Roberts Bank Terminal 2 Project

Part one: Vancouver Fraser Port Authority response to draft conditions and public comment period submissions for the Roberts Bank Terminal 2 Project

April 22, 2022

Figure 1. Overlay of polygon strips used in Appendix IR2020-2.3-E and the two proposed strips in Figure 4 of the Veirs Report: at the north arm of the Fraser River (Veirs North) and at the sound arm (Veirs South).

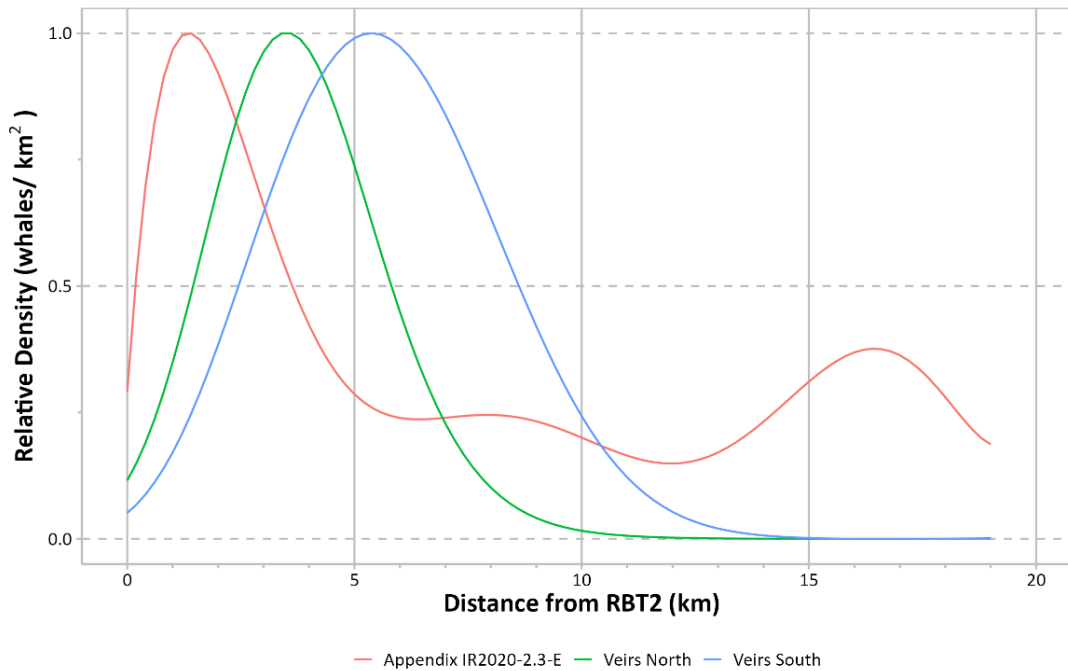
“It would be more precautionary to assume that orthogonal to the berthing face, the foraging activity of SRKW’s is distributed spatially as Figure 4 depicts it north of the fan-shaped travel corridors associated with Active and Boundary Passes. This could be accomplished by orienting the strip orthogonal to the shoreline offshore from the south or north arms of the Fraser River mouth” (p. 9).

“ ... it would be much more precautionary to assume that the maximum observed density in either purple strip in Figure 4 represents the SRKW density at the berth face.” (p. 10)

We are confident that the approach used to estimate CPA used the best available data to determine the proximity of SRKW to the RBT2 terminal berth face (i.e., the IR responses used the empirical sightings data available). This was estimated based on the 16-year comprehensive datasets ($n = 3,572$ sightings) of SRKW sightings from the BC Cetacean Sightings Network (for Canada) and Orca Master (for the U.S.) from 2002 to 2017. We consider the location of the “polygon strip” directly off the proposed berth face to be both logical and defensible.

Notwithstanding, we examined the Veirs Report suggestion to use two alternative strips. We compared the functions of relative whale density as a function of perpendicular distance from the RBT2 berth face. The resulting curves using the location of the strips suggested by the Veirs Report resulted in relative density functions with peaks located further away from the berth face (Figure 1). Both of the new Veirs’ strip selections have peak proximity much further away from the berth face (i.e., less precautionary) than the one used in the acoustic effects model, but neither predict any killer whale transits to occur beyond 14 km from the berth face. The Veirs strips do not reflect that some individuals that are present within 20 km of RBT2 transit on the western (Gulf Island) side of the Strait of Georgia (as documented by NOAA satellite tagging and through focal follow reports by the Centre of Whale Research), which are captured in the polygon strip used in our analyses. We note that these sightings were conservatively included to inform the total number of SRKW transits in the model.

To fully understand the implications of using the suggested alternate “polygon strips”, we repeated the simulations presented in the Appendix IR2020-2.3-E⁷ using the relative whale density functions for both of the proposed strip locations suggested in the Veirs Report (hereafter referred to as Veirs South and Veirs North). The estimates of potential lost foraging time per killer whale using the relative whale density function implemented in Appendix IR2020-2.3-E (Table 1) are similar to those using Veirs South (Table 3) or higher than those using Veirs North (Table 2) and are therefore similar or more conservative than the alternatives proposed in the Veirs Report.

Figure 2. Days of SRKW reports in 2021 in the Pacific Whale Watch Association (PWWA) App from PWWA (2022).

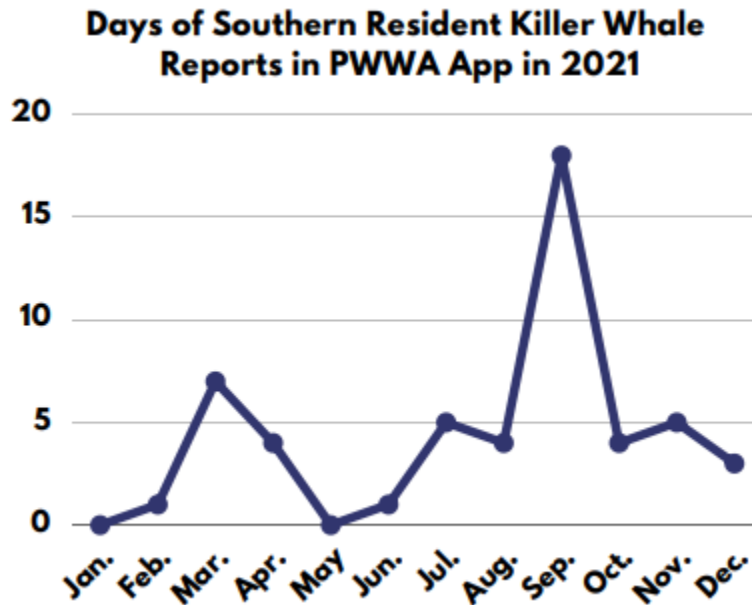
The authors argue that “An even more recent example of this change is 2021 opportunistic sightings of SRKWs within the Salish Sea (Figure 2) that show occurrence was the *opposite* of the seasonal habitat use statistics used by the proponent.” (p. 6).

We reviewed data presented in Figure 2 of the Veirs Report. It was not possible to count the number of sightings within 20 km of RBT2 on the figure and directly compare with the data presented in Appendix IR2020-2.3-E because sources and methods differed. In addition, the order in which data are plotted in Figure 2 of the Veirs Report accentuates September to November sightings, as these are plotted last and will obscure the sightings from other seasons. Due to these challenges in interpreting Figure 2 of the Veirs Report, we investigated the data sources referenced in their figure that were available: Pacific Whale Watch Association report for 2021⁸ and sightings reports on OrcaNetwork for 2021⁹.

We examined the Pacific Whale Watch Association (PWWA) report for 2021 and found that SRKW were reported on 99 days in the entire waters of the Salish Sea, with a marked peak in September 2021 and relatively low sighting days for the rest of the year (Figure 2). This further supports our inclusion of September in the peak use period. We acknowledge an increased variability in SRKW sighting days in recent years but the 2021 PWWA data does not suggest an overall higher use in November to April, which we considered “winter”, than May to October, which we considered “summer” (i.e., it is not an *opposite* pattern to that described in the long-term dataset).

Figure 3. Killer whale hearing sensitivity and communication and echolocation frequency ranges.

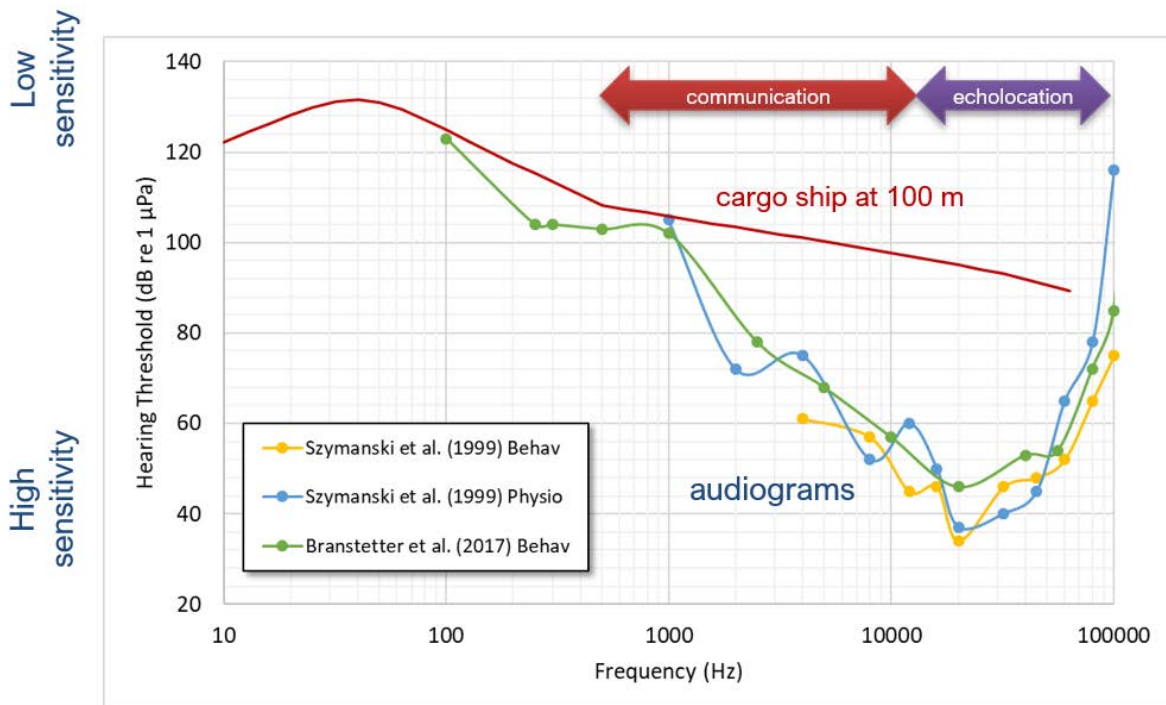
“It must be noted that SRKW are relatively insensitive to noise with frequencies less than about 1 kHz. Hence, the 120 dB ‘broadband threshold’ is actually affecting SRKW because of the acoustic power at the high frequencies used for communication and echolocation, especially where SRKW hearing is most sensitive (Figure 7). Most of the acoustic energy, measured in dB, that is emitted by large ships is in the ‘low frequency’

A frequency band ~10-50 kHz approximately (Figure 7) is the band of frequencies that the SRKW use for communication and for echolocation. It is noise in this frequency region that affects the ability of SRKW to communicate with their conspecifics and to use echolocation clicks to find the salmon prey that they desperately need. The use of the 120 dB broadband threshold of disturbance is predicated on the assumption that broadband noise has high frequency components that affect SRKW behaviour.” (p. 13).

Furthermore, the communication band for killer whales is generally considered to be broader (0.5 to 15 kHz) (Heise et al. 2017) than that suggested by the Veirs Report and extends to frequencies below

1000 Hz. Also, audiogram data show that SRKW can hear at frequencies lower than 1000 Hz, although their hearing is much less sensitive in this range (Figure 3). Therefore, the statement that “Noise at these low frequencies (below 1000 Hz) is not within the hearing range of the SRKW.” (p. 13) is incorrect.
